**[Docket No. FAA-2014-1083; Directorate Identifier 2014-CE-036-AD; Amendment 39-18140; AD 2015-08-04]**

#### **Airworthiness Directives; Various Aircraft Equipped With Wing Lift Struts**

**ACTION:** Final rule.

Figure 1

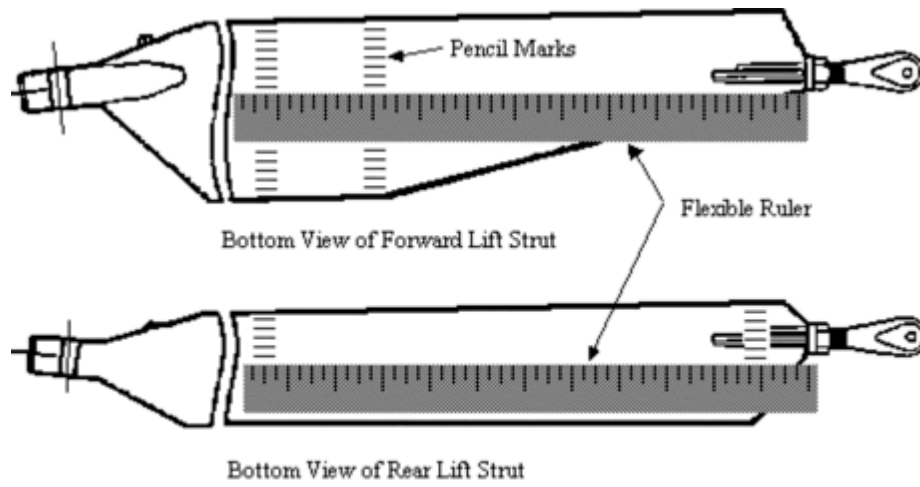
2. Using a flexible ruler, draw a 1/4-inch grid on the surface of the first 11 inches from the lower end of the strut as shown in Piper MSB No. 528D, dated October 19, 1990, or Piper MSB No. 910A, dated October 10, 1989, as applicable. This can be done using a soft (#2) pencil and should be done on both faces of the strut. As an alternative to drawing a complete grid, make two rows of marks spaced every 1/4-inch across the width of the strut. One row of marks should be about 11 inches from the lower end of the strut, and the second row should be several inches away where the strut starts to narrow. Lay the flexible ruler between respective tick marks of the two rows and use tape or a rubber band to keep the ruler in place. See Figure 1.
